Product / Process Change Notification (PCN)

PCN #: PCN_UtRJ45LAN_20200109

Affected Series: WE-UtRJ45LAN-Series; 749xxx; S171xxx

DESCRIPTION AND PURPOSE OF CHANGE:

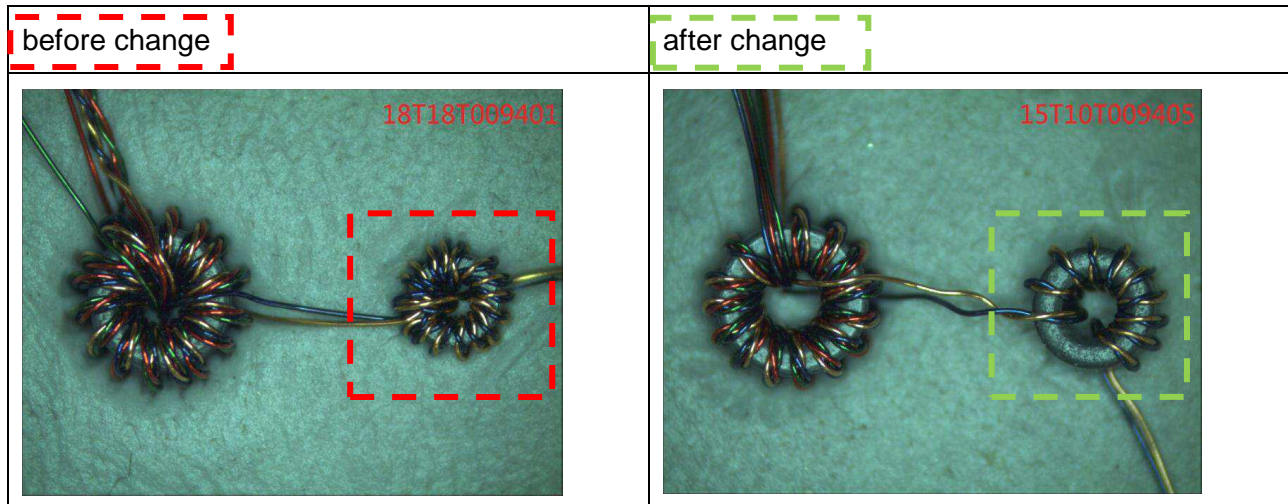
To ensure an improved product assembly, Würth Elektronik will optimize the product design.

This change allows the implementation of an automatic winding process.

All products with date code 2020-01-09 or later, will be affected by this change.

There will be no change in fit, function, quality or reliability of the product.

DETAIL OF CHANGE:

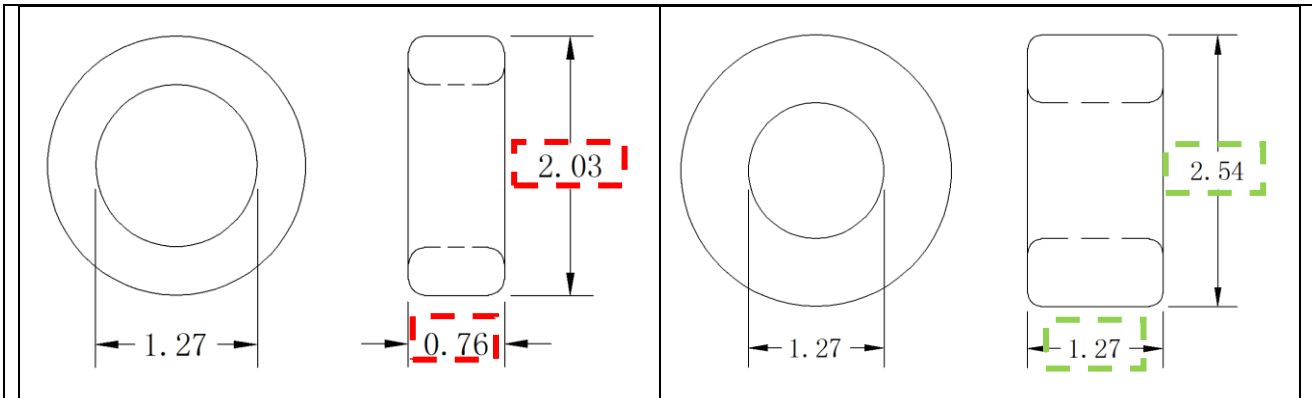
The electrical specifications, as shown in the data sheet, will not change.
